## Landscape Review Committee Hybrid In-Person & ZOOM Online Meeting

Committee Members	Agenda Items
Jamie Fleckenstein, Chair	Call to Order and Roll Call     Citizen Comments
Brian Wicks,	3. Action Items
Vice Chair	A. <b>L 4-25</b> : Street Tree Plan and Landscape Plan Review for Hillcrest Phase 7, Tax Lot R4524 00801 (no site address), <i>(Exhibit 1)</i>
Carlton Davidson	4. Discussion Items
Lee McCollins	A. Arbor Day Event Update
Eva Reutinger	5. Committee Member Comments
	6. Staff Comments
	7. Adjournment

### EXHIBIT 1 - STAFF REPORT

**SUBJECT:** Landscape Plan Review Application L 4-25

#### 3b. Applicant's Street Tree Plan

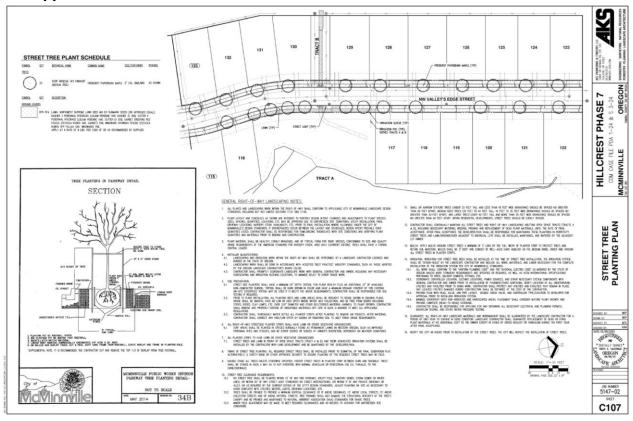
- 1. The applicant shall submit a revised street tree plan and landscape plan with the following for approval:
  - a. Street Tree Plan.
    - i. Based on the spacing of street trees, the applicant shall select different street trees from the City's street tree list which have wider canopy at maturity, consistent with MMC 17.58.090(C). Trees shall be selected from the large trees on the list with specifications for mature height and width consistent with the spacing and suitable for the planter strip size.

- iv. Where spacing of driveways is 35 feet or greater, the applicant may also consider planting two smaller trees between each pair of driveways to achieve spacing of 20 feet with trees planted five feet away from the driveway aprons, which may require adjustments to locations of utility services, to be approved by Engineering and McMinnville Water & Light.

- v. The applicant shall update the street tree planting specification in the plan set to the City's current specification. The current specification provides for the root barrier along the back of curb and along the sidewalk to be 10 feet in width, centered at the street tree.

- vi. Street tree planting spec is wrong spec. Shall updated with current spec, which requires 10-wide root barrier.
    - vii. Existing trees within this phase, including those to be retained and removed, shall be shown on the plan. Tree retention and removal shall be consistent with the Planning Development and Subdivision conditions of approval.

#### 3c. Applicant's Landscape Plan for Open Space Tract

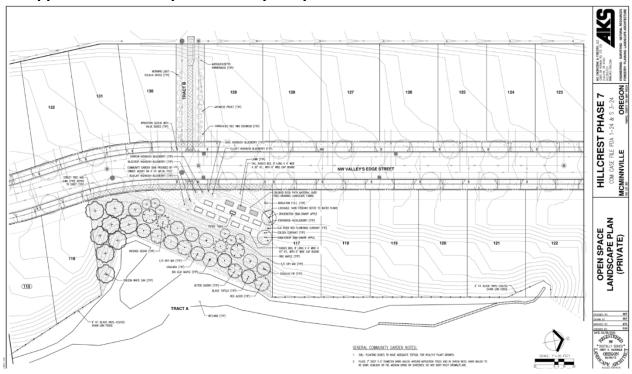
- b. Landscape Plan.
    - i. The applicant shall specify a different picnic table which shall be accessible to wheelchairs.

- ii. The applicant shall specify a wheelchair accessible raised planter box for at least two of the raised planter beds, with a cleat area beneath the raised planter box or an inwardly-sloping side to the raised planter box.
- iii. Show any proposed on-site lighting. Indicate the method of shielding/downcast lighting to demonstrate artificial lighting which may be provided shall be deflected as not to shine or create glare in any residential zone or on any adjacent dwelling. (MMC 17.57.070(B)(1)

#### 3e. Applicant's Wetland Restoration Plan

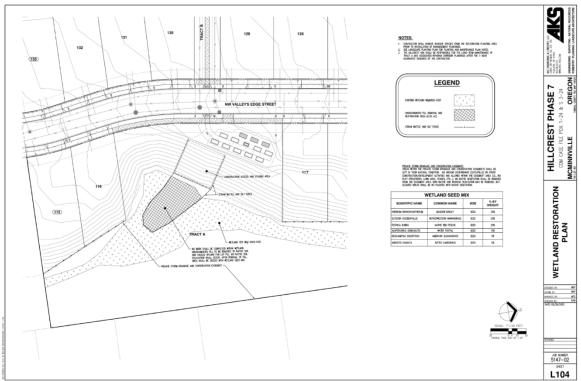
- d. The applicant shall complete the remediation of the wetland where fill was previously placed, consistent with the plan submitted by the applicant and authorized by the Oregon Department of State Lands (DSL). *Note:* The applicant will need to submit photographs of the completed work to DSL.
- 3. The applicant should call for locates (dial 811) for all underground utilities prior to digging. This is a free service, and upon request, utility locations can be flagged without marking up hard surfaces.
